STATE OF UTAH
NATURAL RESOURCES
Oil, Gas & Mining

September 20, 1985

RE: Approval with One Condition, Amended 4th East Tube Conveyor, Wilberg/Cottonwood Mine, ACT/015/019, #3, #4 and #7, Emery County, Utah

PLAN
TYPICAL SITE

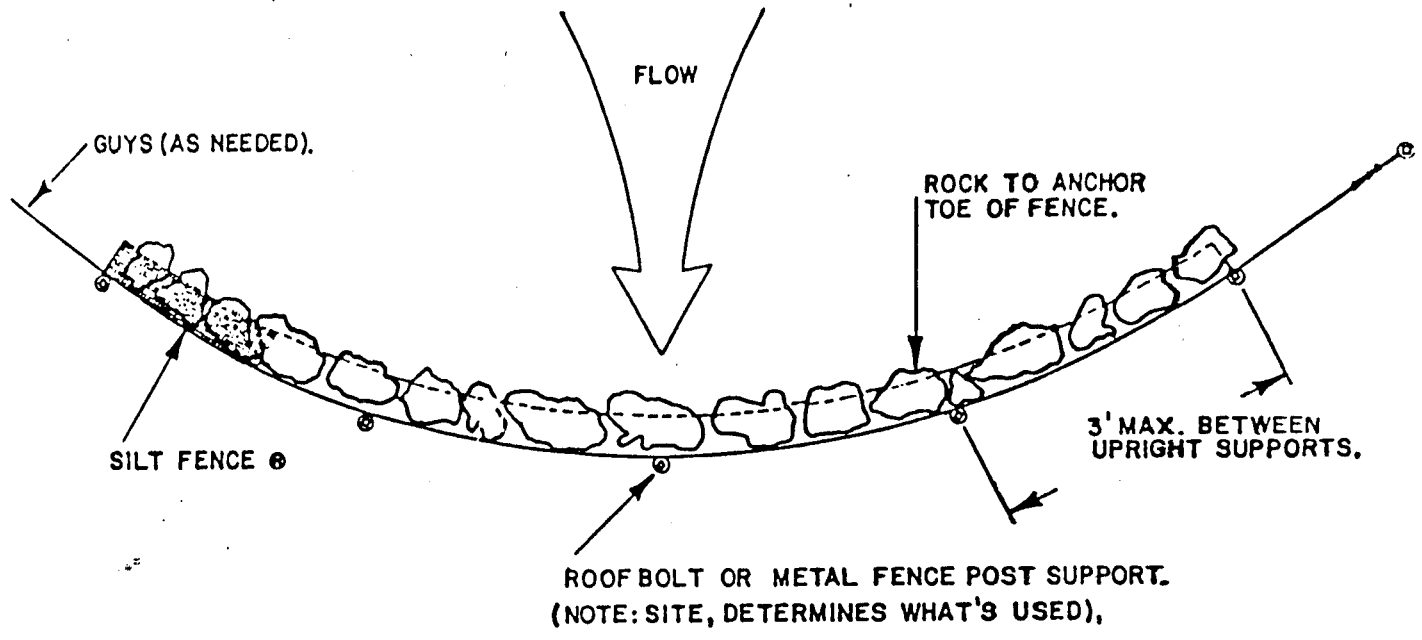
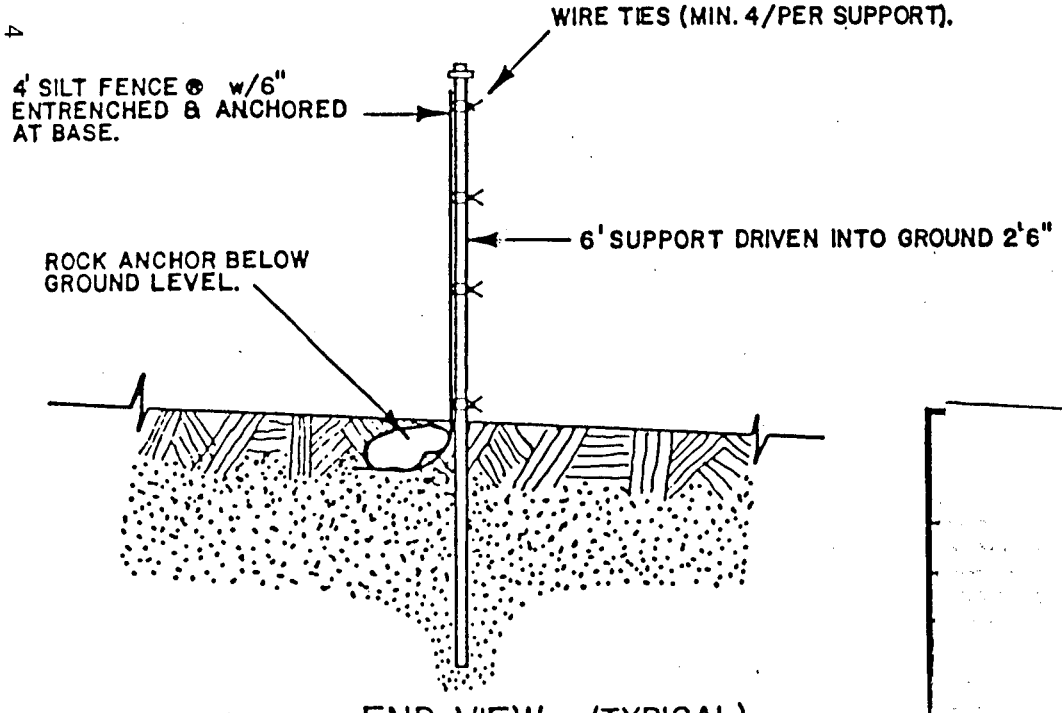
The Division hereby approves the amended 4th East Tube Conveyor Plan as submitted September 19, 1985 and requires as a condition to this approval the implementation of the attached design on the silt fence installation for the bent structure pad. This silt fence installation will require maintenance and must be inspected closely to insure it functions properly.
